UNITED STATES PATENT AND TRADEMARK OFFICE

APPLICATION NO.	FILING DATE	FIRST NAMED INVENTOR	ATTORNEY DOCKET NO.	CONFIRMATION NO.
10/032,606	10/19/2001	Kevin R. Keegan	89190.072901/DP-304631	8160
7590 04/13/2004 Delphi Technologies, Inc. P.O. Box 5052 Mail Code 480414420 Troy, MI 48007			EXAMINER ALEJANDRO, RAYMOND	
			ART UNIT 1745	PAPER NUMBER
DATE MAILED: 04/13/2004

Office Action Summary

DETAILED ACTION

FIGURE 2

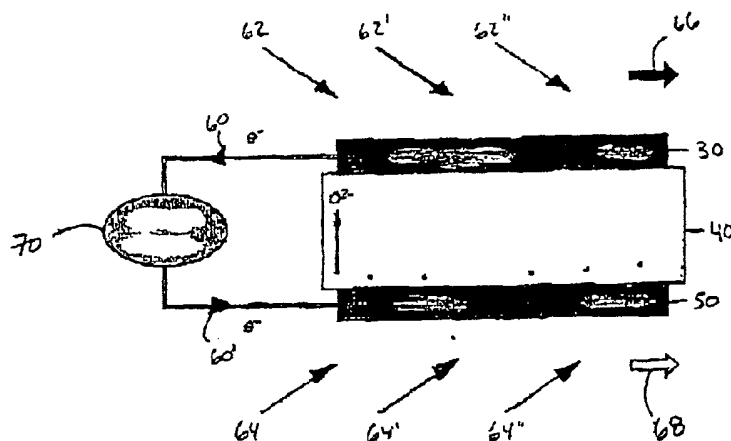
Figure 2 below illustrates an solid oxide electrochemical fuel cell in operation producing a current flow as shown by current flow arrows 60 and 60'. Oxidant gases, such as oxygen or air, can be introduced to the cathode side of the cell, flowing as illustrated by the oxidant flow arrows 64, 64' and 64". The reaction of the fuel and oxide ions, producing electrons (e-), which flow outside of the electrochemical cell 10 to the external circuit 70 and back to the cathode 50 (SECTION 0024). At the anode, the oxide ions react with a fuel, such as hydrogen which as introduced to the electrochemical cell 10 as illustrated by the fuel flow arrows 62, 62' and 62" (SECTION 0025). It is further disclosed that the electrolyte 40 conducts these oxides ions (O^{2-}) between the anode 30 and the cathode 50, maintaining an overall electrical charge balance. The cycle of flowing electrons (e-) from the anode 30 through the external circuit 70 to the cathode

50 creates electrical energy for harnessing (SECTION 0027). Mieney et al teach that an end cap 20 includes a surface 22 that is configured for disposal adjacent to the anode 30 to provide fuel distribution; and an interconnect 24 includes a first interconnect surface 26 which is configured adjacent to the cathode 50 to provide oxidant distribution (SECTION 0019). It is also disclosed that oxide ions flow through the electrolyte 40 (SECTION 0029 & 0020). Therefore, considering that anode 30, cathode 50 and the solid electrolyte 40 each has a three dimension structure (volume or 3D), it is contended that fuel and oxidant distribution flow areas represented by reference numerals 66 (the fuel stream arrow), reference numeral 62, 62' and 62'' (the fuel flow arrows), reference numeral 68 (the oxidant stream arrow) and reference numeral 64, 64' and 64'' (the oxidant flow arrows), respectively, are generally **non-parallel and/or orthogonal (intersecting or lying at right angles or having perpendicular slopes or tangents at the point of intersection)** to the flow of oxygen ions (O^{2-}) through the electrolyte 40 as illustrated below in Figure 2. In particular, fuel flow arrows 62, 62' and 62'' and oxidant flow arrows 64, 64' and 64'' are non-parallel to the oxygen ions flow; and fuel stream arrow 66 and oxidant stream arrow 68 are orthogonal to the flow of oxygen ions.

Examiner's note: *As to the limitation that "resistance to the flow of electric current through the cell is non-uniform over a flow area of the cell" or "the electrical resistance is non-uniform over one of said anode, cathode or electrolyte", it is contended that the electrical resistance of any body is intrinsically related to the chemical nature of its construction material, therefore, since the construction material of each of the fuel cell components i.e. the anode, the cathode, the electrolyte, the separator; the end plate and the likes differs from one another, any fuel cell will exhibit non-uniform resistance to the flow of electric current through the cell over the areal extent thereof or over the anode, the cathode or the electrolyte. Accordingly, each fuel cell component presents a varied appearance of electrical resistance pattern due to its material composition. In addition, given that (as disclosed by the applicant, see specification at page 3, lines 17-22) the resistance is higher in areas of the cell having locally low levels of hydrogen than in areas having locally high levels of hydrogen, that is to say, the higher the concentration of hydrogen the lower the resistance is at a local fuel cell point/site, it is thus contended that hydrogen concentrations (level) inherently varies from the anode inlet to the anode active area and all over along the anode outlet, that is to say, the hydrogen concentration at a local anode point such as the inlet is different, due to hydrogen consumption or elimination, than the hydrogen concentration at another local anode point such as the outlet. This also applies to the cathode active area, including the inlet and the outlet but, of course, using oxygen instead of hydrogen as the flowing fluid. Thus, it is asserted that having shown that the construction material of each particular fuel cell component is chemically different from each other as well as a necessary variation or gradients in hydrogen concentration along the anode surface itself, the above-mentioned characteristic, property and/or function is hence inherent as the construction*

Figure 2 above, in particular, shows fuel stream arrow 66 and oxidant stream arrow 68 which are orthogonal to the flow of oxygen ions.

FIGURE 2

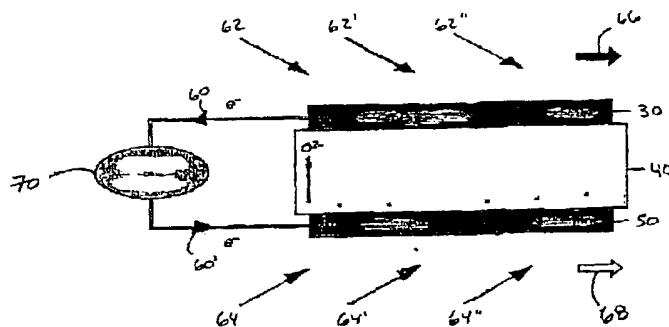
As explained above, **Figure 2** illustrates an solid oxide electrochemical fuel cell in operation producing a current flow as shown by current flow arrows 60 and 60'. Oxidant gases, such as oxygen or air, can be introduced to the cathode side of the cell, flowing as illustrated by the oxidant flow arrows 64, 64' and 64". The reaction of the fuel and oxide ions, producing electrons (e-), which flow outside of the electrochemical cell 10 to the external circuit 70 and back to the cathode 50 (SECTION 0024). At the anode, the oxide ions react with a fuel, such as hydrogen which as introduced to the electrochemical cell 10 as illustrated by the fuel flow arrows 62, 62' and 62" (SECTION 0025). It is further disclosed that the electrolyte 40 conducts these oxides ions (O^{2-}) between the anode 30 and the cathode 50, maintaining an overall electrical charge balance. The cycle of flowing electrons (e-) from the anode 30 through the external circuit 70 to the cathode 50 creates electrical energy for harnessing (SECTION 0027). Mieney et al teach that an end cap 20 includes a surface 22 that is configured for disposal adjacent to the anode 30 to provide fuel distribution; and an interconnect 24 includes a first interconnect surface 26 which is configured adjacent to the cathode 50 to provide oxidant distribution (SECTION 0019). It is also disclosed that oxide ions flow through the electrolyte 40 (SECTION 0029 & 0020). Therefore, considering that anode 30, cathode 50 and the solid electrolyte 40 each has a three dimension structure (volume or 3D), it is contended that fuel and oxidant distribution flow areas represented by reference numerals 66 (the fuel stream arrow), reference numeral 62, 62' and 62" (the fuel flow arrows), reference numeral 68 (the oxidant stream arrow) and reference numeral 64, 64' and 64" (the oxidant flow arrows), respectively,

are generally non-parallel and/or orthogonal (intersecting or lying at right angles or having perpendicular slopes or tangents at the point of intersection) to the flow of oxygen ions (O^{2-}) through the electrolyte 40 as illustrated below in Figure 2. In particular, fuel flow arrows 62, 62' and 62'' and oxidant flow arrows 64, 64' and 64'' are non-parallel to the oxygen ions flow; and fuel stream arrow 66 and oxidant stream arrow 68 are orthogonal to the flow of oxygen ions.
